TA 16

Date: **NOV 25 2009**
Refer To: EP2009-0632

Subject: Request for Deviations from the Approval for the Investigation Work Plan for the S-Site Aggregate Area

Proposed sampling locations for the courtyard, adjusting for restricted access because of historical preservation

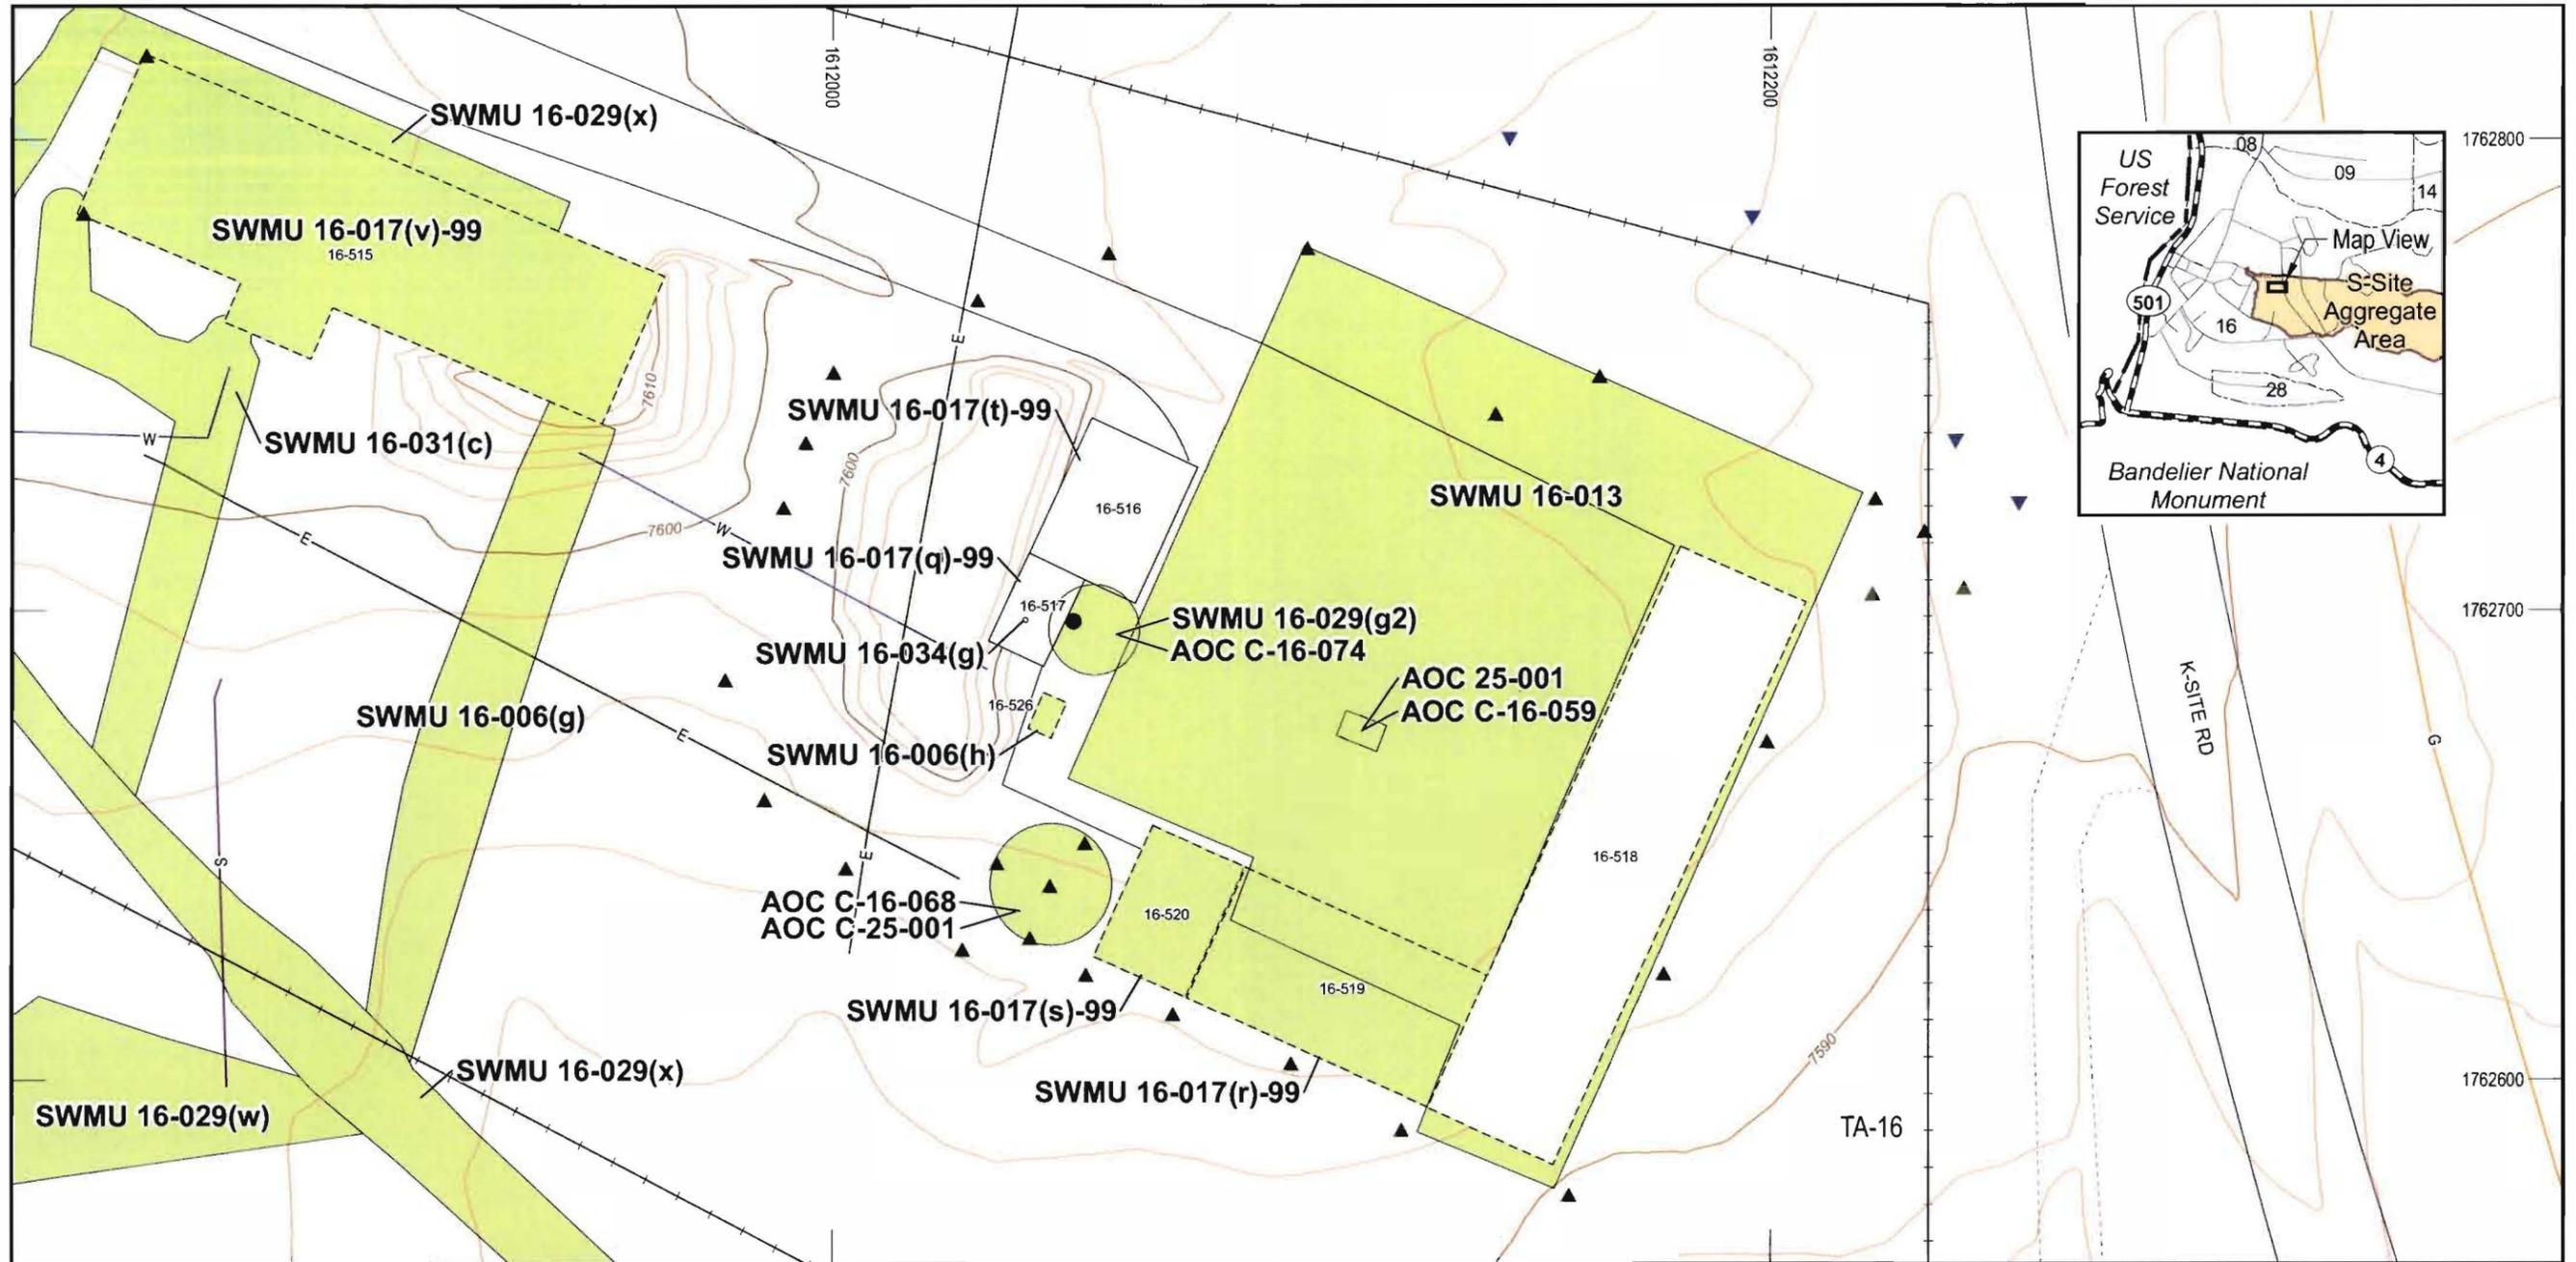
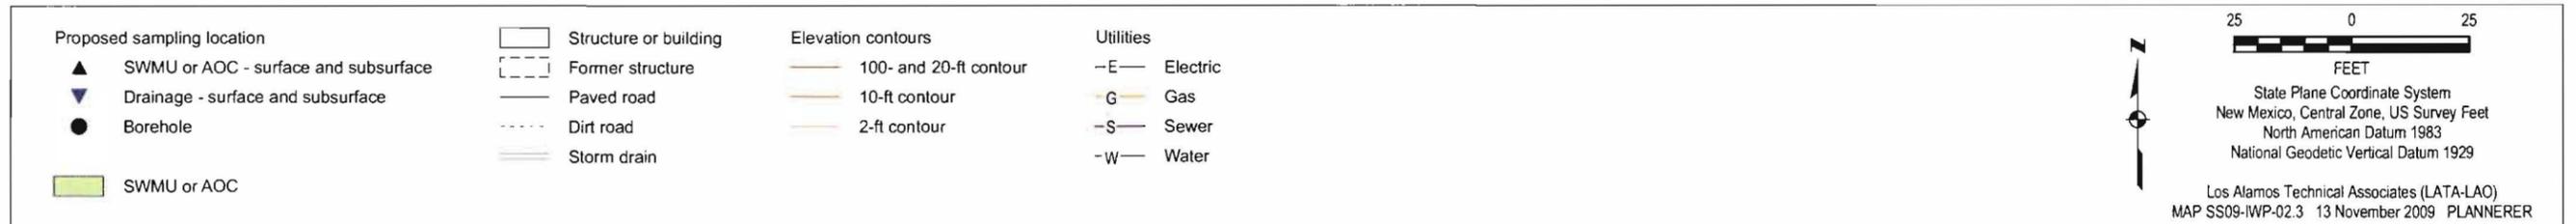
Proposed surface and subsurface sampling locations following consideration of the historical preservation requirements are shown on the attached figure. Surface and subsurface sampling locations have effectively been removed from the historically preserved area and placed around the periphery of the site and between the berms separating buildings 16-515 and 16-516. As per the approved work plan, samples will be collected from the surface (0.0 – 0.5 ft) and subsurface (5.5 – 6.0 ft) at each location and submitted for the same suite of analytes as presented in the plan. One borehole within SWMU 16-029(g2) (former shaker table) remains in the sampling plan because this location is a former borehole that was not plugged or patched. This borehole will be drilled to the depth specified in the approved plan and samples will be analyzed per the approved plan.
